MARKET & VALENCIA

01-29-2019

Market / Valencia

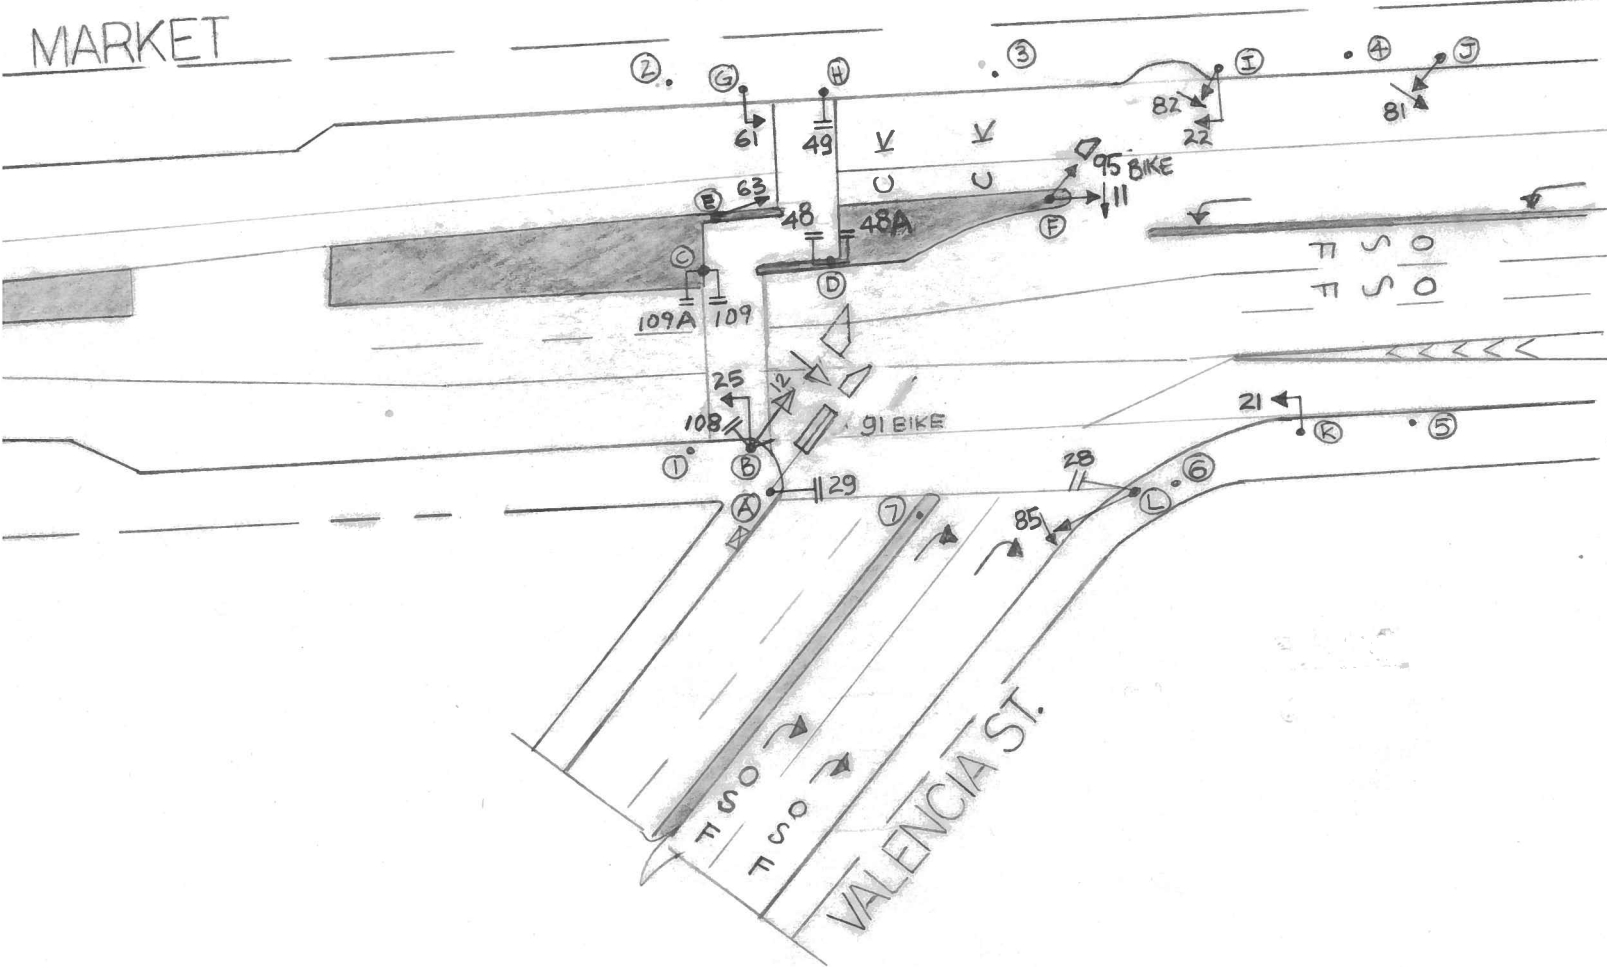
COMMENTS : PER SRC 2019-009, MOVE EXISTING SIDE-MOUNTED BIKE SIGNAL 91 FROM POLE B TO POLE A. ADD ANGLED VISOR FOR SIGNAL 12.
